REMARKS

Inventors: Polzin et al. Appl. No.: 10/772,692 ANNOTATED SHEET

Title: SEPARABLE APPARATUS TO CUSHION AND DAMPEN VIBRATION AND METHOD

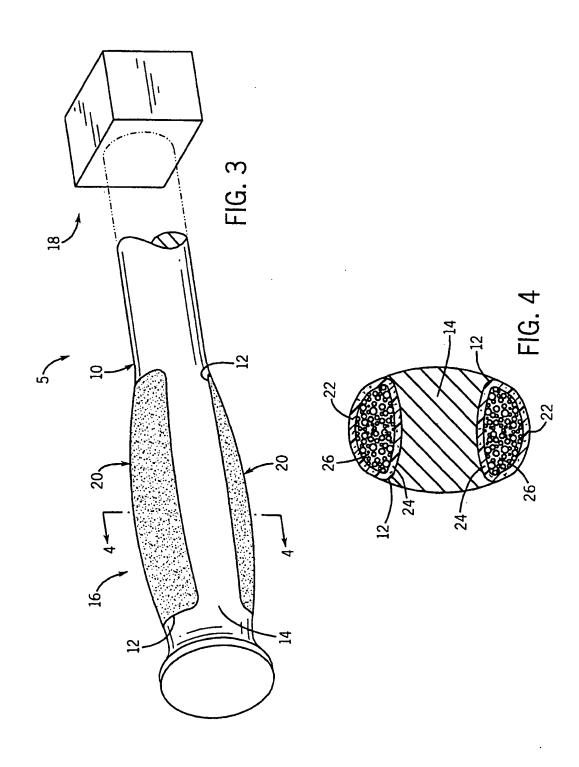
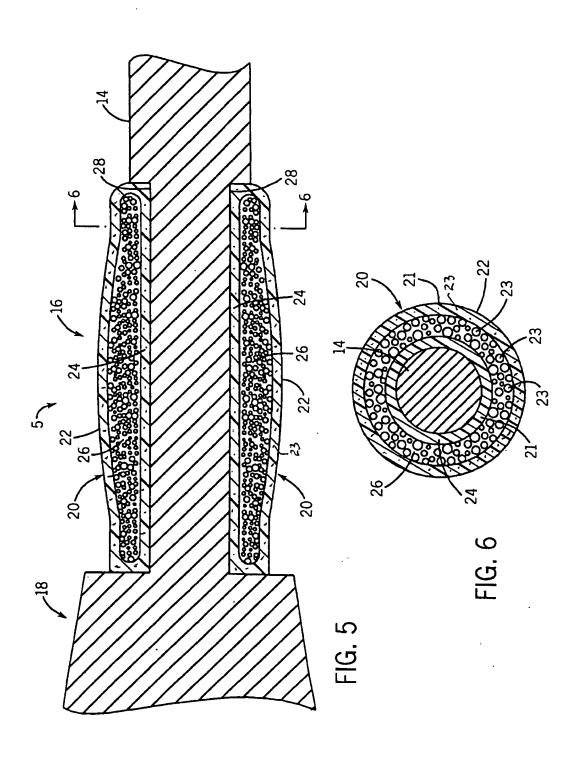
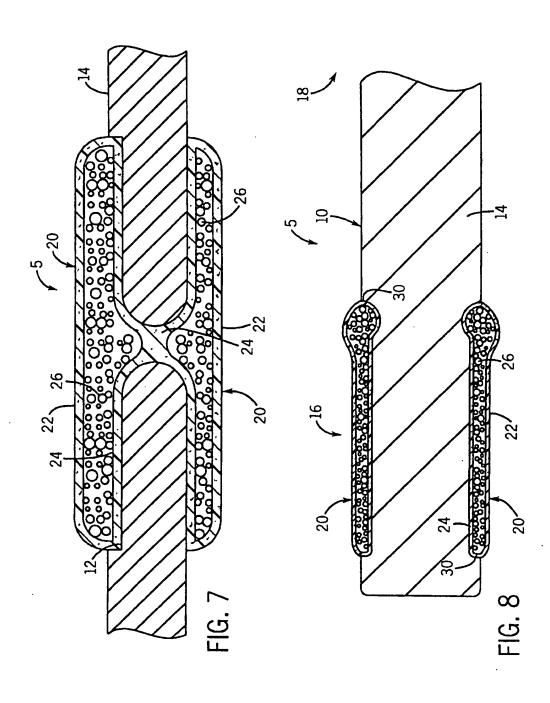
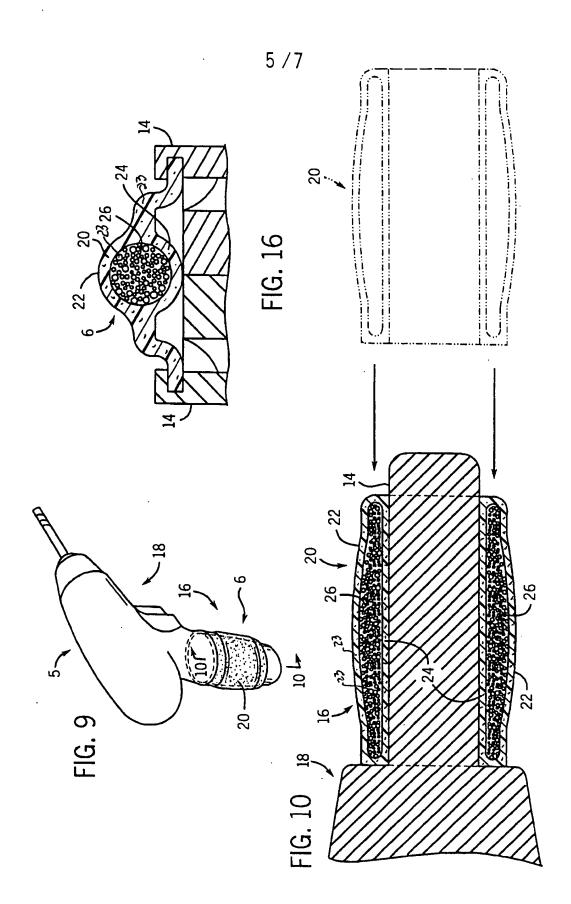
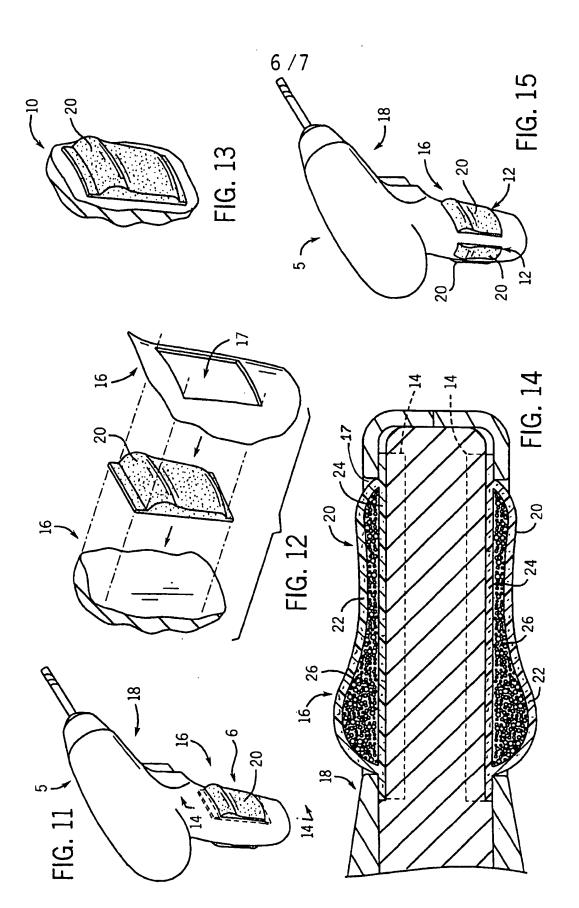
The drawing Figures 4-8, 10, 12, 16, and 17 have been amended. Appended to this amendment is an annotated copy of the previous drawing sheet which has been marked in red to show changes presented in the replacement sheet of the drawing.

The specific changes which have been made to the referenced figures is an indication of the foaming agent 23 in each of the first and second layer 22, 24 of the separable apparatus.

As discussed at least in paragraph 0047 and 0048 the foaming agent 23 is retarded in the first and second layer but expanded in the enveloped micro-cellular layer 26.
